WOLF CREEK NUCLEAR GENERATING STATION
CONSTRUCTION SELF ASSESSMENT CORRECTIVE ACTION EVALUATION

PERFORMED BY DELIAN CORPORATION

KANSAS GAS & ELECTRIC

JANUARY 11, 1985

VII. CORRECTIVE ACTION

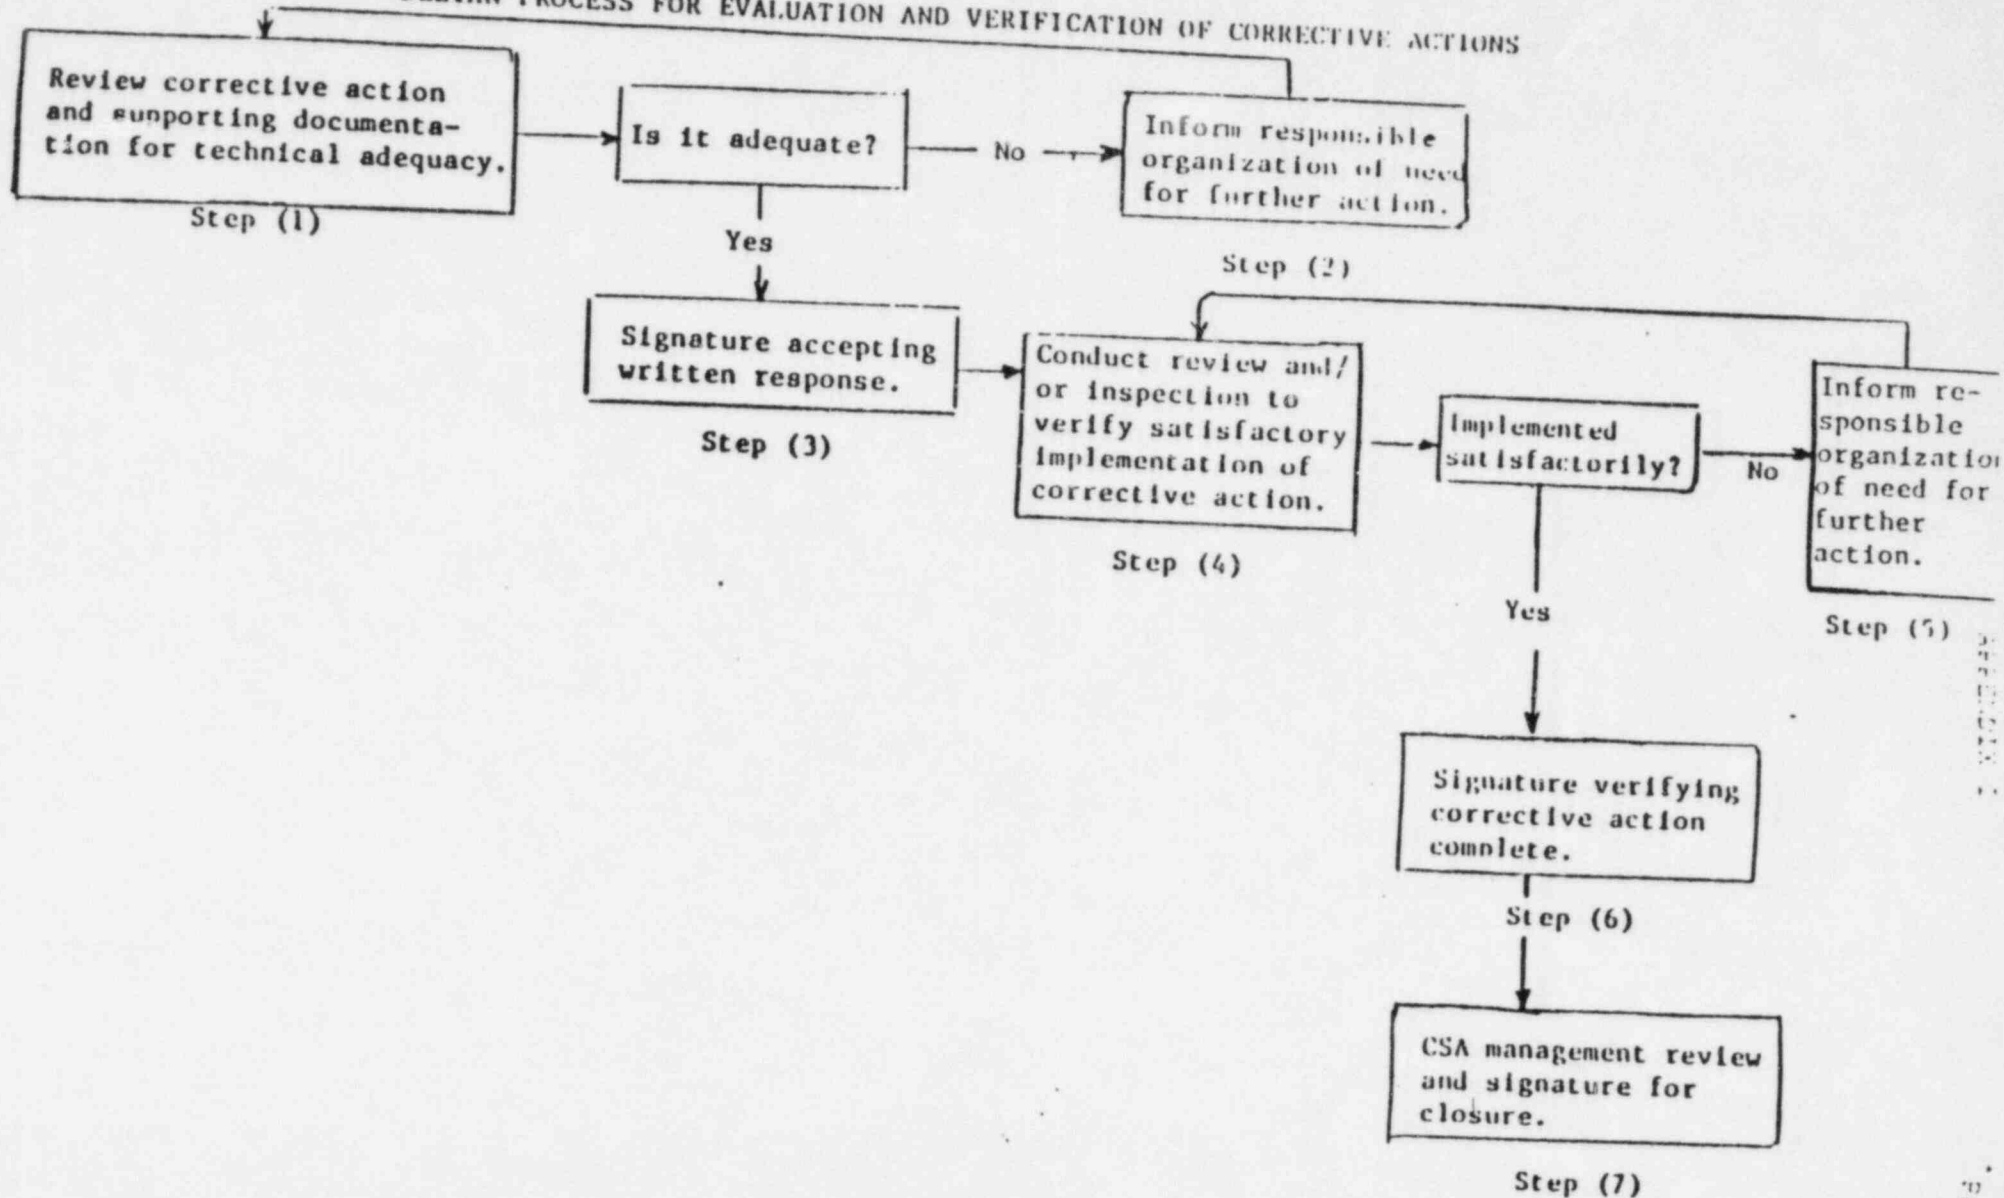
- (1) Problem: Lower spreader room, 1J1G5C/1J1G60, minimum bend radius concern. J1P cable has 1.75" allowable. Cables are: 1JEI02NC, 1LEI12AB, 1LFI11BB, 1LFI11CB, and 1LFI11LB. E-1R3514 Revision 4. First addressed by NRC on 10-27-84. NRC questioned how the actual bend radius measurement was calculated.

Response: 2" bend radius actually found. The bend radius was verified by the use of a template.
